MAINTENANCE NOTE 17 (for Electronics Technicians)

ART-2 Pylon Wiring and Phasing Verification

ART-1/2 MAINTENANCE NOTE 19 (for Electronics Technicians)

SUBJECT : Audio Radiotheodolite (ART)-1/2 Receiver Alignment

Figure 2
Elevation Assembly
Wiring Diagram

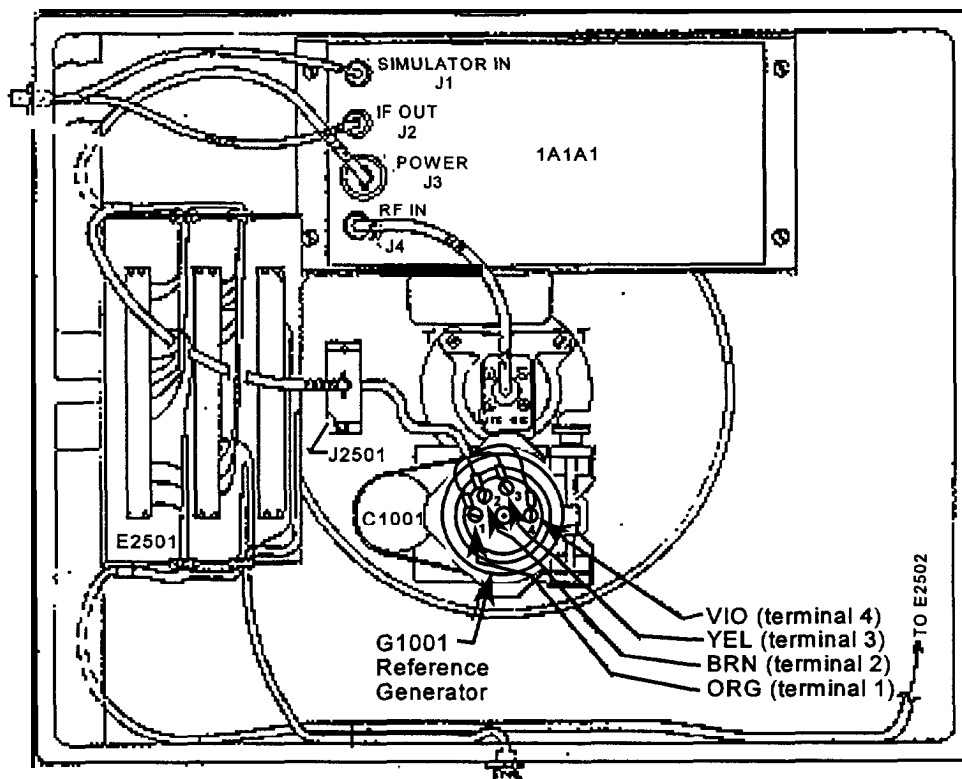
Make pen and ink changes to the Instruction Manual Automatic Radiotheodolite ART-2, 2R, Maintenance Vol. 2, Figure 7-10, Elevation Assembly 1A2, Wiring Diagram, pages 7-39/40. Pen and ink changes should reflect the proper reference generator wiring diagram as outlined in Figure 2 of this modification note.

2. Locate the pylon reference generator and verify proper reference generator wiring as shown in Figure 2.

6. If any of the wiring schematics in Figures 2, 3 and 4 do not match the sites' ART-2 elevation housing configuration, rewire the elevation housing as specified in Figures 2, 3 and 4.
7. Recheck the wiring with an ohm meter, as detailed in step 3 and verify that all terminal screws on the reference generator and E2501 are tightened properly.
8. Turn target antenna power on.
9. At the R/ACU, turn system power on.
10. At the R/ACU, slew the antenna assembly to the approximate target antenna angles and allow the ART to lock on to the target antenna signal.
11. If the ART antenna locks onto the target antenna signal, wiring in the elevation housing is correctly configured. If difficulties are encountered, confirm the system wiring with drawings in Figures 2, 3, and 4.
12. Replace elevation housing rear cover 1A2A12 with the 14 captive screws.

Figure 3
Reference Generator to J2501 Wiring

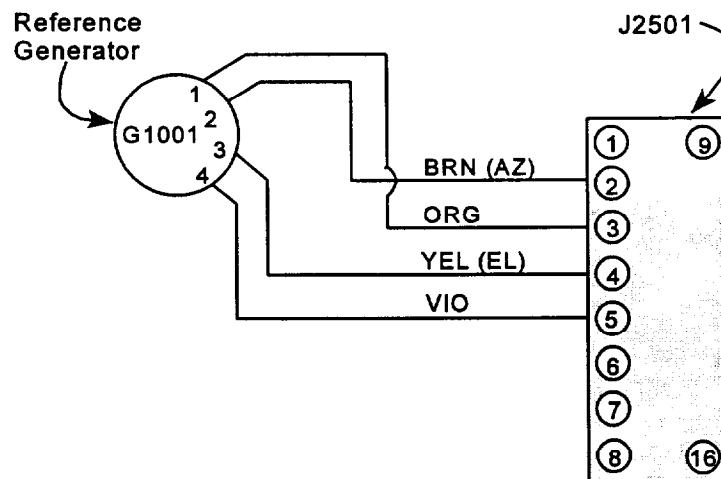
3. Locate J2501 on the back of the pylon. Unplug P2501 and with a digital volt meter (DVM) perform the following continuity checks:
 - a. Set the DVM to the ohm scale.
 - b. Insert the black DVM lead into A3-D on the test panel in the R/ACU drawer.
 - c. Verify that continuity exists (less than 1 ohm) between A3-D and screw terminal 3 on the reference generator.
 - d. Insert the black DVM lead into A4-D on the test panel in the R/ACU drawer.
 - e. Verify that continuity exists (less than 1 ohm) between A4-D and screw terminal 2 on the reference generator.
4. If any of the above tests fail, verify elevation assembly wiring with the wiring diagram in Figure 3.

Figure 4
P2501 and E2501 Wiring

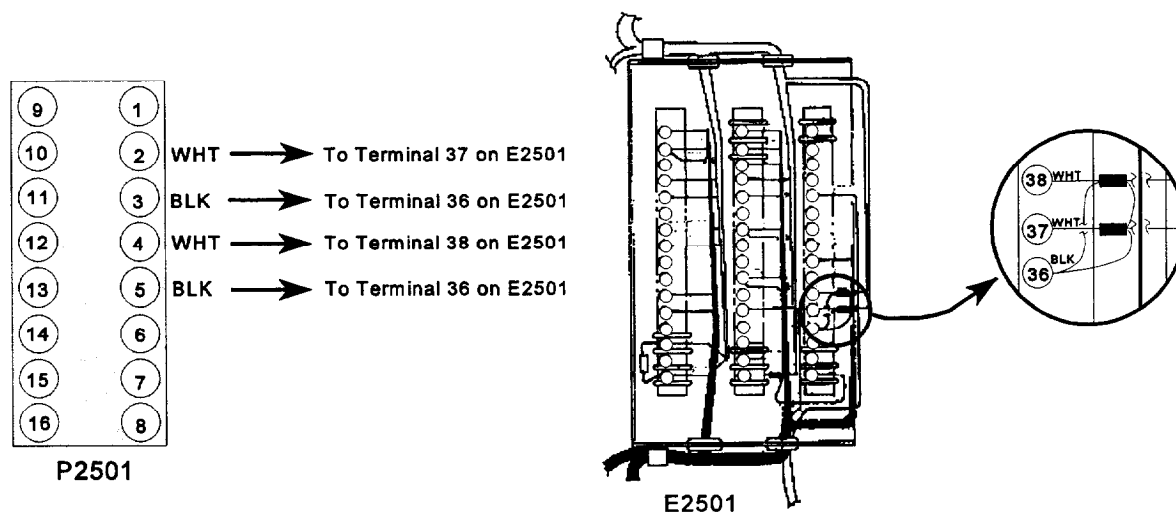
5. Verify the wiring from P2501 to E2501 in the elevation housing assembly according to the schematics in Figure 4.
